Campaign No. 2021050003, May, 2021

SUBJECT: **Model 907 Sprinter, Model Year 2019-2020**
Inspect Power Steering Hose Clamps

Mercedes-Benz AG (“MBAG”), the manufacturer of Mercedes-Benz and Freightliner vans, has determined that on certain Mercedes-Benz and Freightliner Sprinter vehicles from platform 907 (VS30), the hydraulic power steering return line hoses may detach at their connection points under certain operating conditions and may cause hydraulic fluid to leak resulting in the loss of power steering. If the hydraulic power steering hose detaches, the driver will still have manual steering functionality, but increased steering effort is needed, particularly at low speeds. Sudden loss of power steering as well as the loss of hydraulic steering liquid to the road surface may increase the risk of a crash. An authorized Mercedes-Benz or Freightliner Sprinter dealer will check the return line connections of the power steering system and if needed, install the respective replacement clamp.

D46.25-A008-79

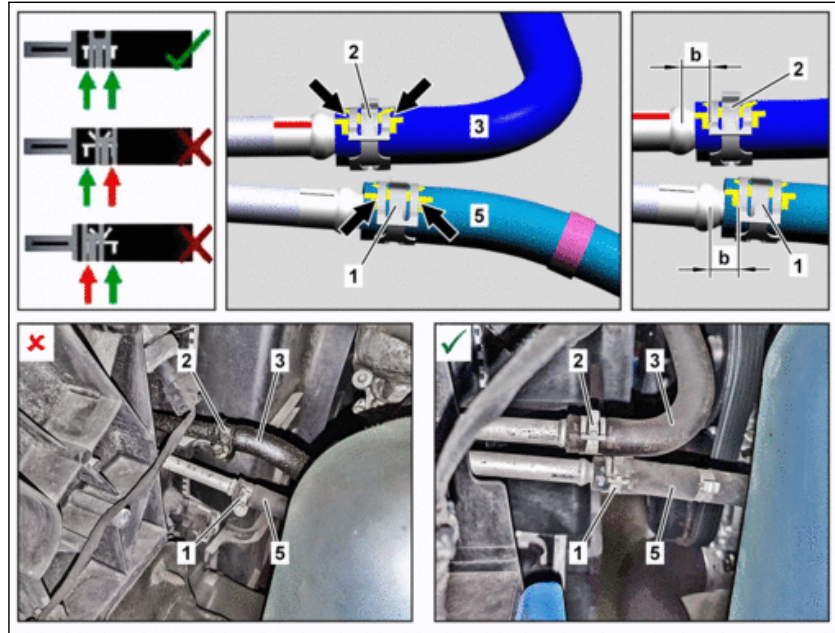
All 3 clamps (1, 2, 4) together with the listed connections must always be checked.

On vehicles with engine 642, the as-built configuration may deviate slightly (see first picture), which does not impair the procedure shown here.

2	Remove air ducting (8).		
3	Check hydraulic hoses and clamps (1, 2) of power steering.	<p>i</p> <p>Check the following points:</p> <ul style="list-style-type: none"> → Check both connections of hydraulic lines for leak tightness. → Check installation position of clamps (1, 2) on respective hydraulic hose. The clamps must be seated centrally between the markings (arrows) on the hoses. <p>Also check whether the distance indicated by dimension (b) is maintained. See specification in picture.</p> <p>If clamps (1, 2) are not correctly positioned or if there is a leakage (see fail image above),</p> <p style="text-align: center;">↓</p> <p>replace affected clamp (1, 2). To do so, see operation step 5 onward in reference document.</p> <p>Replace clamps on hydraulic hoses of power steering (code: NV3LETULPX, acc. no.: 46 950 80)</p>	<p>SM46.25-D-0032-02SG</p>

4	Check return hose (3) and clamp (4) at power steering expansion reservoir.	<p>i</p> <p>Check the following points:</p> <ul style="list-style-type: none"> → Check connection of return hose (3) at power steering expansion reservoir for leak tightness. → Check whether return hose (3) is pushed on power steering expansion reservoir up to end stop. → Check installation position of clamp (4) on power steering expansion reservoir. The clamp (4) must be seated centrally between the markings (arrows) on the return hose (3). See specification in picture. If markings (arrows) are no longer visible, then check distance against dimension (a). <p>If clamp (4) is not positioned correctly or if a leakage is present,</p> <p style="text-align: center;">↓</p> <p>reposition affected clamp (4). To do so, see operation steps 1 to 4 in reference document.</p> <p>Replace clamps on hydraulic hoses of power steering (code: NV3LETULPX, acc. no.: 46 950 80)</p> <p>If all specifications and test criteria of operation steps 3 and 4 are fulfilled,</p> <p style="text-align: center;">↓</p> <p>install air ducting (8) and end measure.</p>	SM46.25-D-0032-02SG
